Mamre Road upgrade between the M4 Motorway and Erskine Park Road

Addendum review of environmental
factors
April 2024

This document is an addendum Review of Environmental Factors (Addendum REF) for a proposed modification to the approved 'Mamre Road upgrade between the M4 Motorway and Erskine Park Road' project (the approved project).

Figure 3-1: Proposed property acquisition

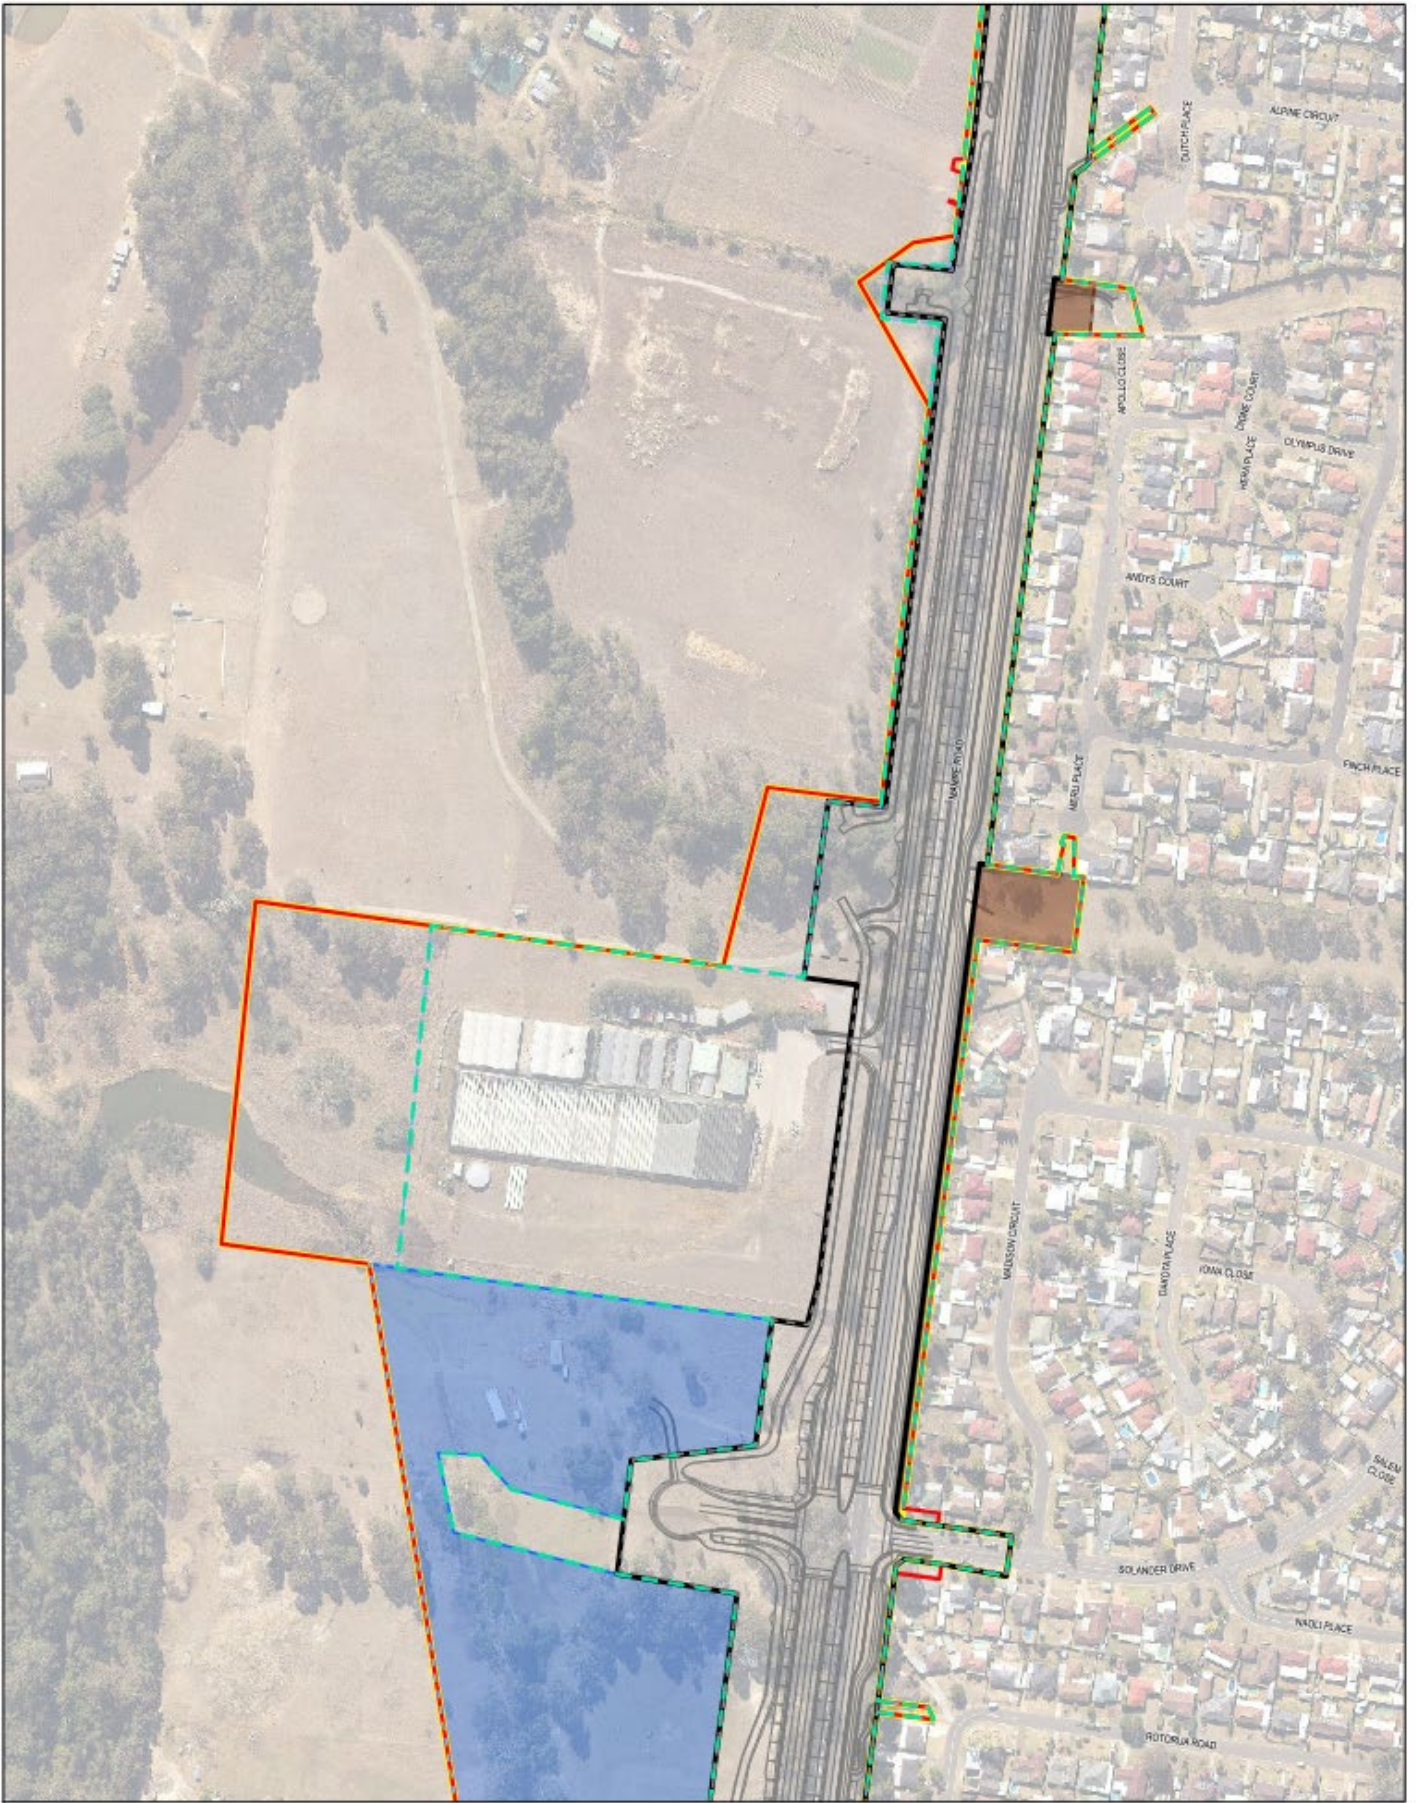
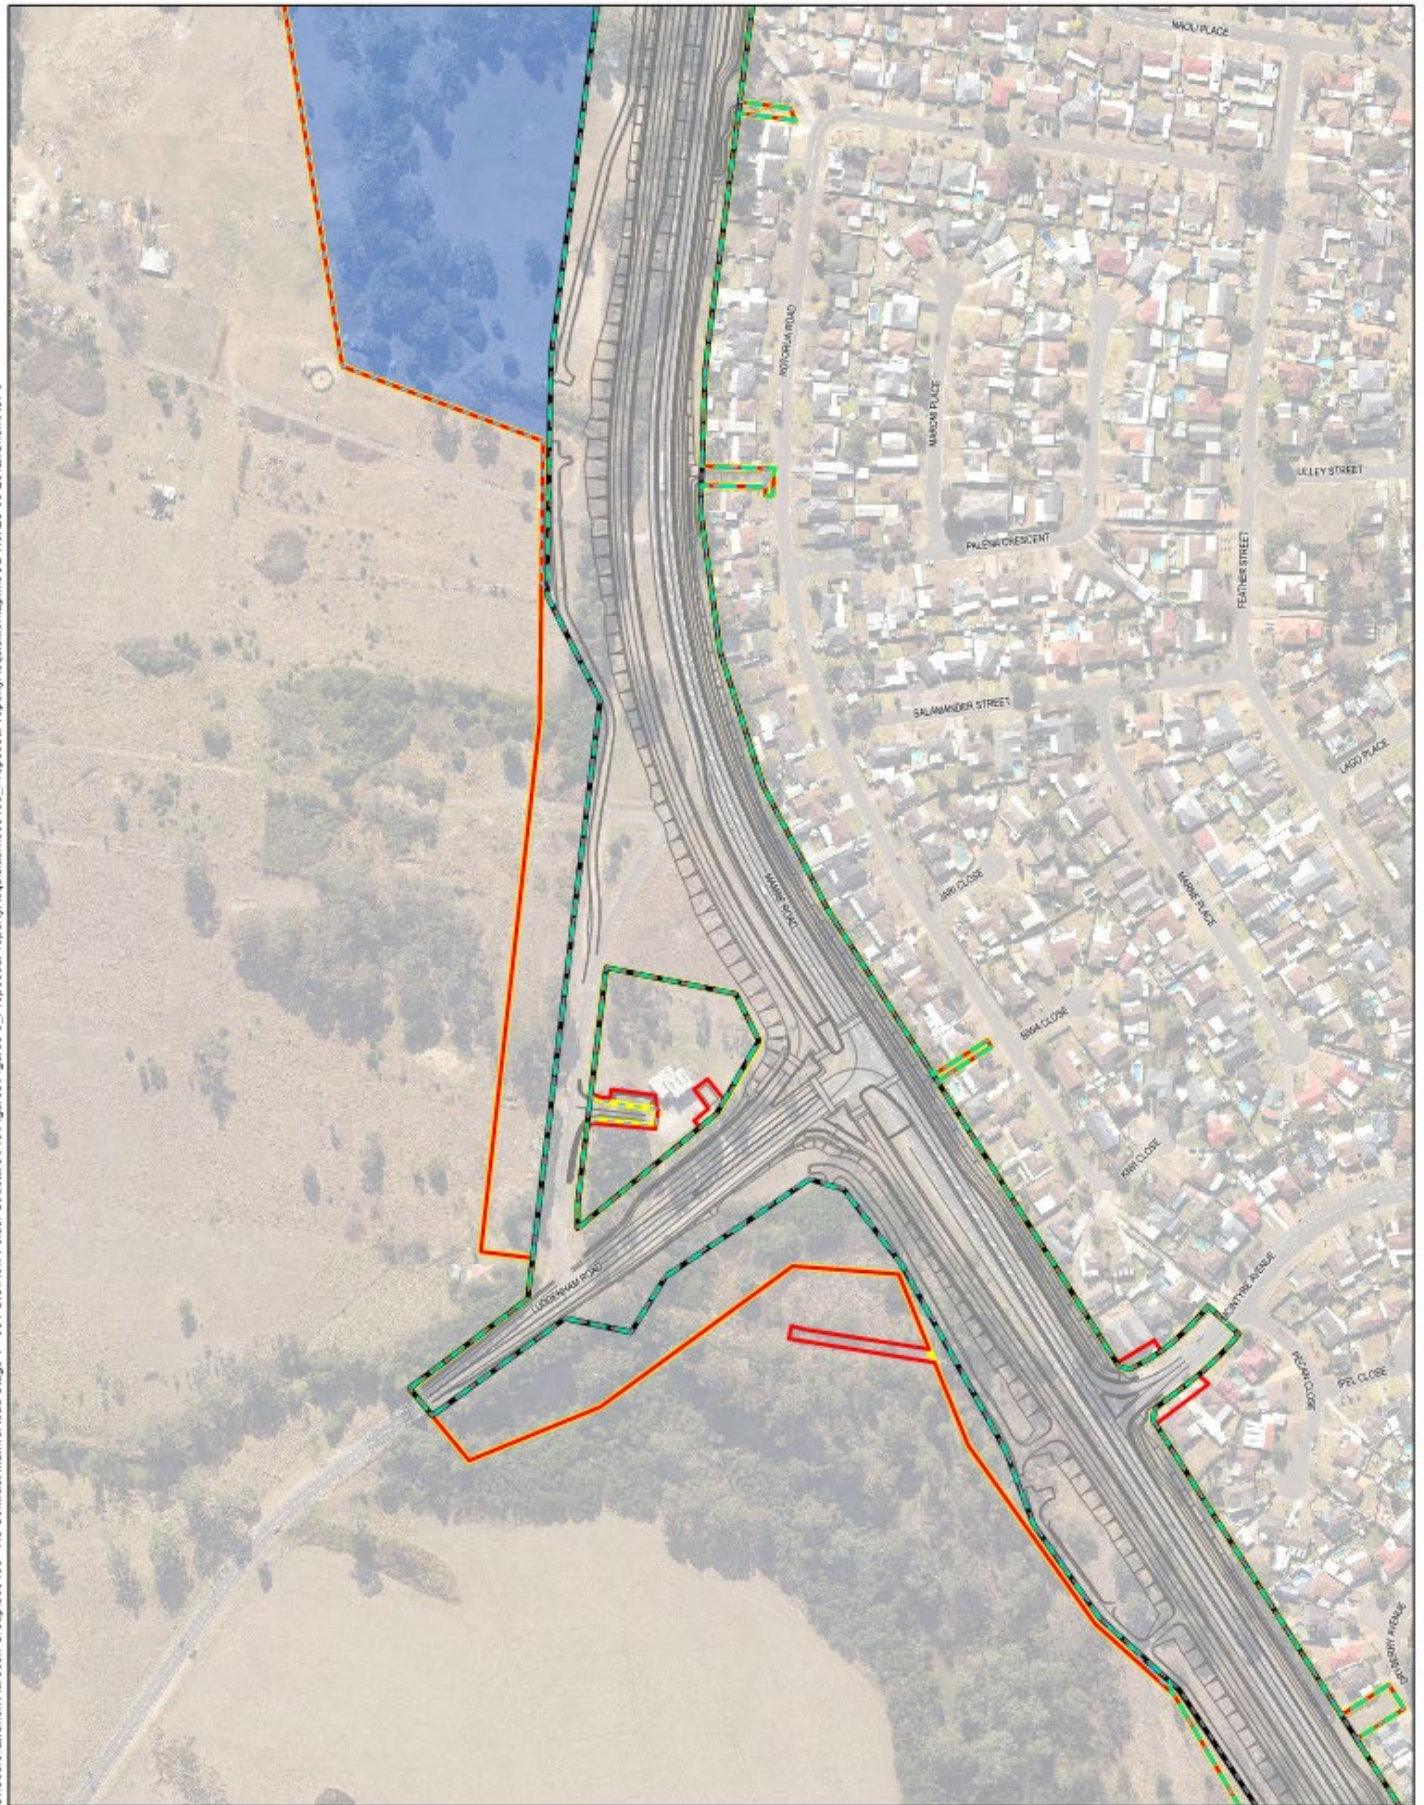
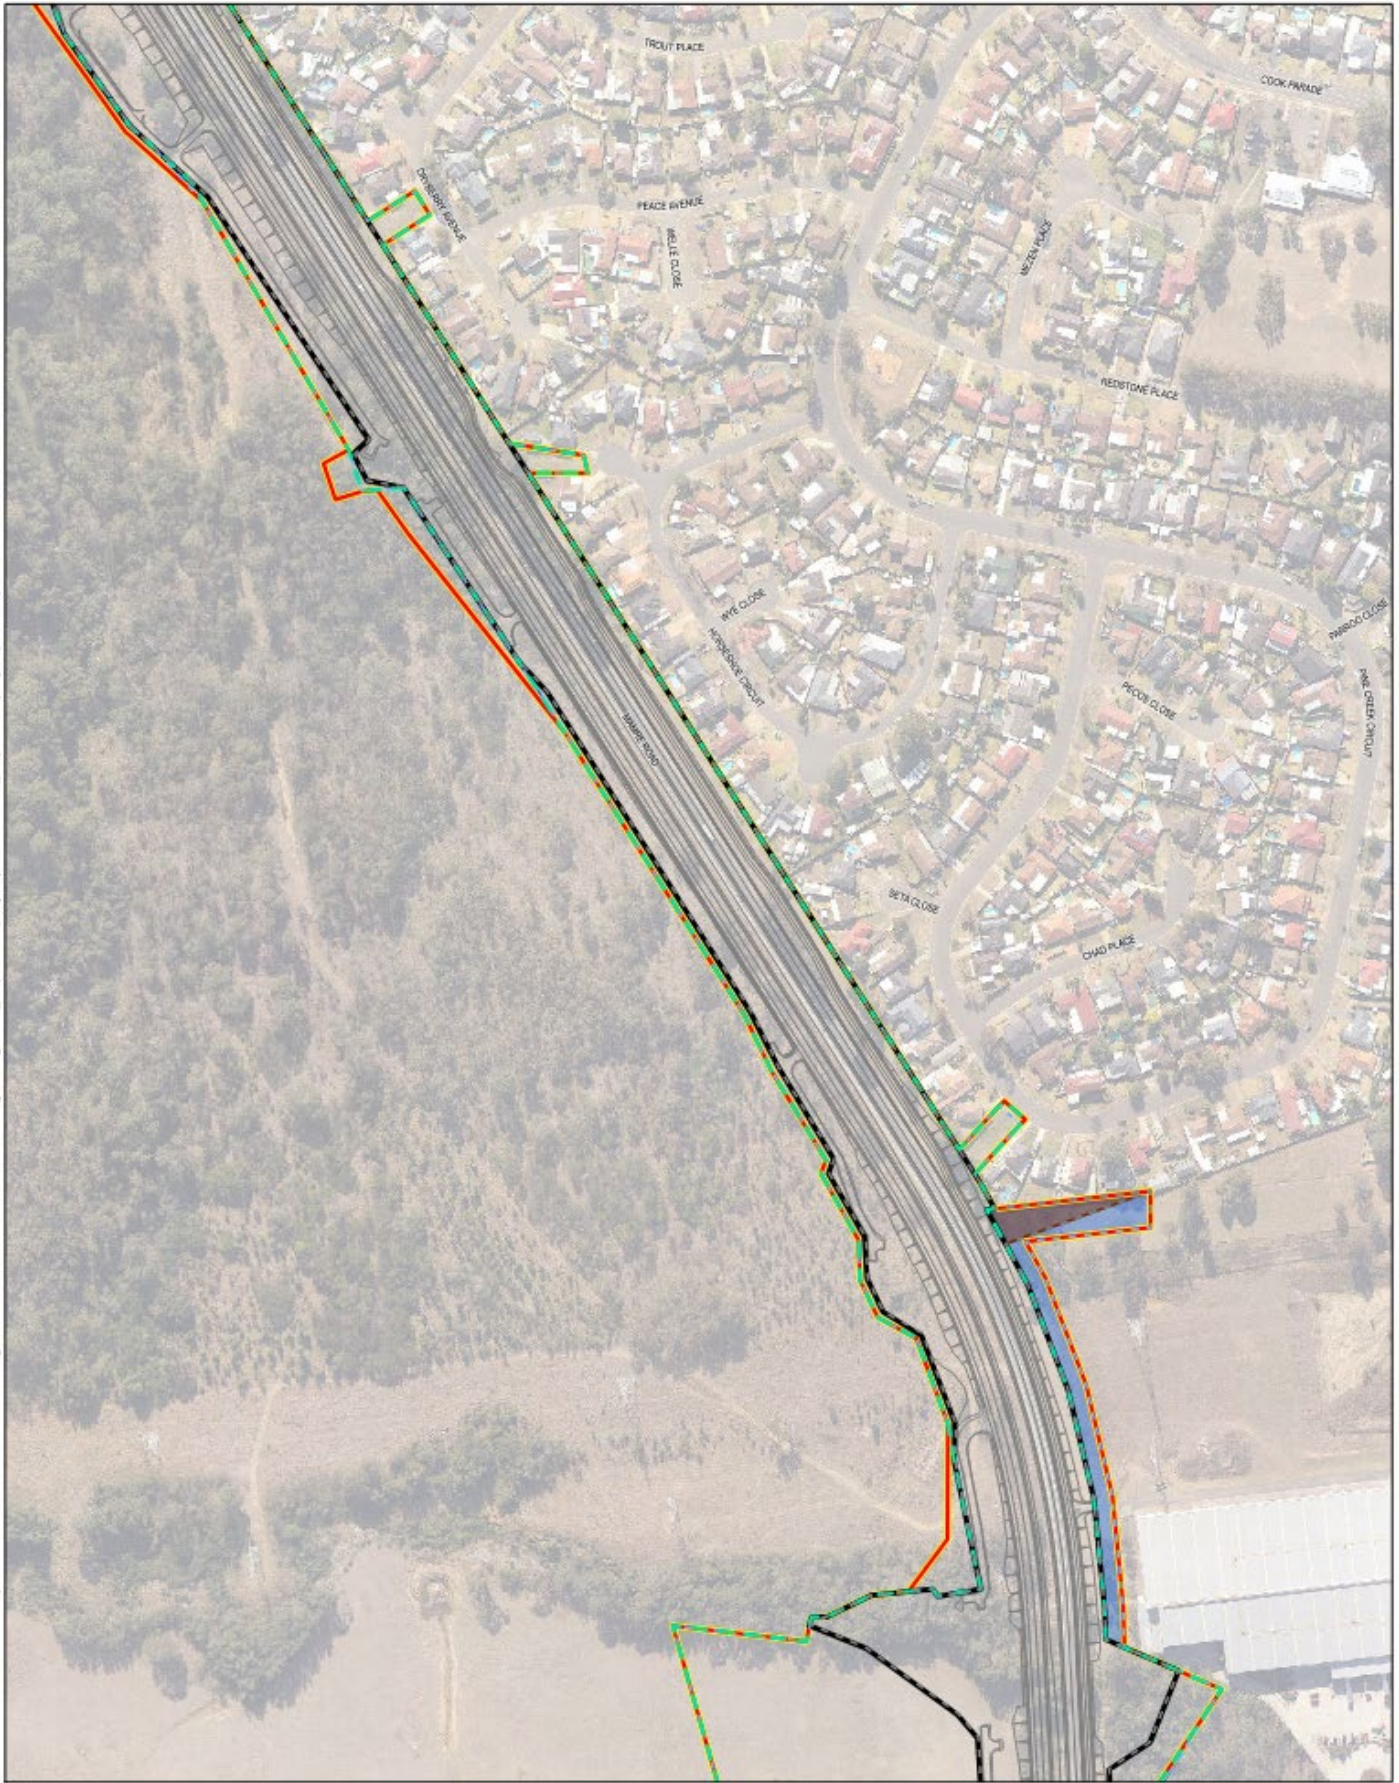
Several major utilities have been identified within the proposal area that would require adjustment and/or relocation. As a result of further consultation with relevant utility providers, the requirements for utility adjustments have been refined and are captured within the proposed modification boundary. The proposed modification would involve additional utility adjustment to those considered in the project REF. This includes a water main which would require excavation along Walker Lane beyond the approved proposal area, which would result in an extension to the boundary.
